Information Request

Our Reference: MCUI/2026/3870 &
RAL/2026/3871
CS Portal Reference: N/A
Contact Officer: Sophie Spencer
Contact: (07) 4688 6808
Email: development@tr.qld.gov.au

Development Application for: Material Change of Use - Medium Impact Industry, Outdoor Sales, Warehouse and Caretakers Accommodation, and Reconfiguring a Lot - Reconfigure 2 into 3 Lots and Access Easement

Location: 39 and 53 Foundation Street, WELLCAMP QLD 4350

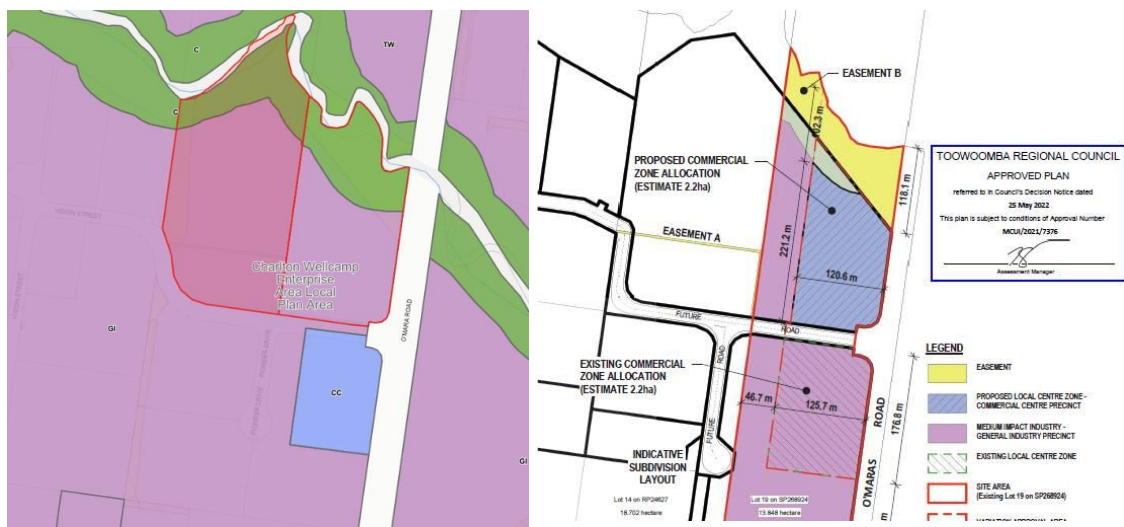
Issue:
1.1	There is a Preliminary Approval MCUI/2021/7376 for Variation Approval on the south-east corner of the subject premises. This Variation Approval effectively swapped the location of the Local Centre Zone from south of Foundation Street, to a new designation north of Foundation Street. See figures below. Stage 3 is for Medium Impact Industry and Outdoor Sales, and would be located on the relocated Local Centre designation. These uses are listed as inconsistent uses with a Local Centre under AO1.2 of the Local Centre Zone Code. Furthermore, the uses are not consistent with the purpose of the Commercial Centre Precinct of the Charlton Wellcamp Enterprise Area Local Plan Code. While a description of Stage 3 operation has not been provided, it appears the development relates to large scale machinery repairs or machining and may involve the outdoor display of large machinery or vehicles. These land uses are not consistent with the purpose of the Local

Centre Zone nor the Local Plan's Commercial Centre Precinct.

As such, there is a fundamental conflict between the proposed development and the current Preliminary Approval, more specifically:

- There is no material demonstrating no economic, planning and community need for a Local Centre, having regard to need for a local centre in the future as the industrial precinct develops; and
- The current application is seeking to override the Preliminary Approval without an appropriate planning mechanism e.g. Variation Request.

Two approvals that facilitate two fundamentally different developments, cannot coincide. Consequently, this conflict must be resolved prior to deciding the current development application.

It is recommended the existing preliminary approval is cancelled, meaning that the local centre returns as per the current zoning under the Planning Scheme. This will mean proposed Stage 3 will be on Medium Impact Industry Zoned land, and the conflict with the underlying zoning/designation will be removed.

Conflict between the proposed development and the Preliminary Approval MCUI/2021/7376 as described above must be resolved, ensuring the proposed development would not compromise a local centre from being delivered to service the needs of workers in the surrounding area. It is recommended the existing preliminary approval is cancelled.
